Delegated officer report for planning application

Application no. 143012/NMC/2025

Proposal: Non-material amendment to planning approval reference 139997/FO/2024 to allow an alteration to the office entrance, from the North West corner of the building, to the North East corner of the building, with subsequent adjustments to the car parking layout

Address: Land At Welcomb Street, Openshaw, Manchester

Unit 4- Previously approved internal layout

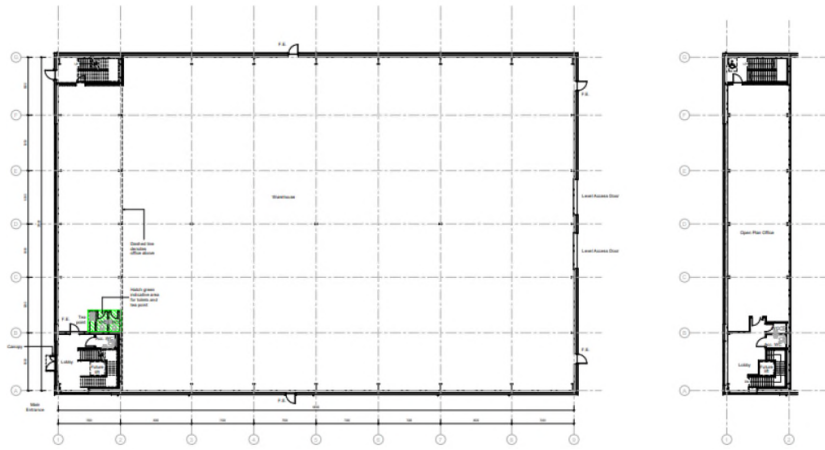
Consent is sought to translocate the main entrance with the personnel entrance, from the north west corner of the building, to the north east corner, with the personnel door moving to the former proposed location of the main entrance, with associated cladding colouration arrangement changes. This amendment has also led to the re-positioning of the disabled bays to be in close proximity the relocated main entrance and dropped curbs to accompany this, and revisions to the location of parking spaces where electric charging points and spaces with ducting provision are sited.

The number of parking spaces, spaces for disabled users, spaces with EV charging points and spaces with ducting for future EV provision remains the same.

Unit 4- Proposed translocation of the main entrance and personnel access on northern elevation

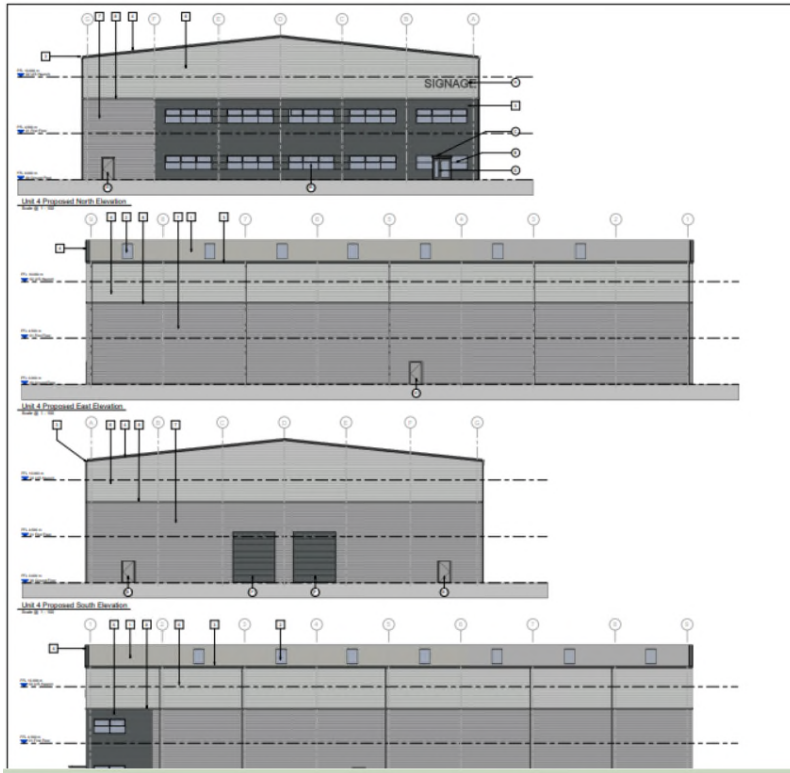
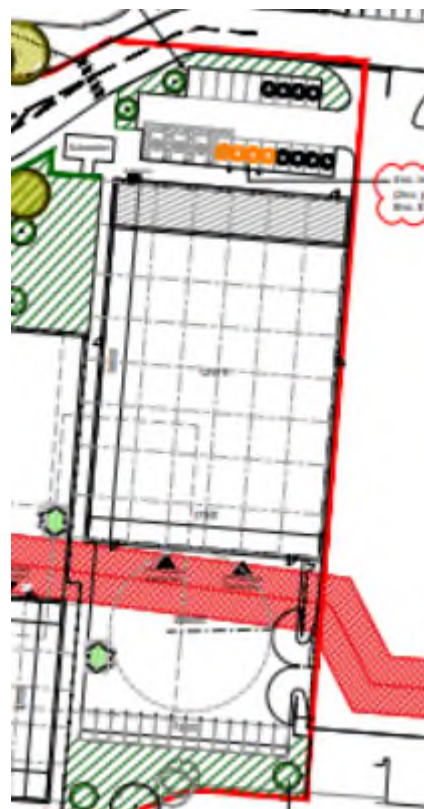
- Translocation of the main entrance and the personnel access on the northern elevation with associated cladding colouration arrangement changes.
- Relocation of the parking spaces for disabled users to be close to relocated main entrance and changes to the location of parking spaces where electric charging points and spaces with ducting provision. The number of parking spaces, parking spaces where electric charging points and spaces with ducting provision would remain unchanged.

It is considered that the proposed revisions would not have a detrimental impact in terms of the visual appearance of the commercial development, or the visual and residential amenity of the properties in proximity to the site. The revisions would also not adversely affect parking provision and servicing arrangements for the development.
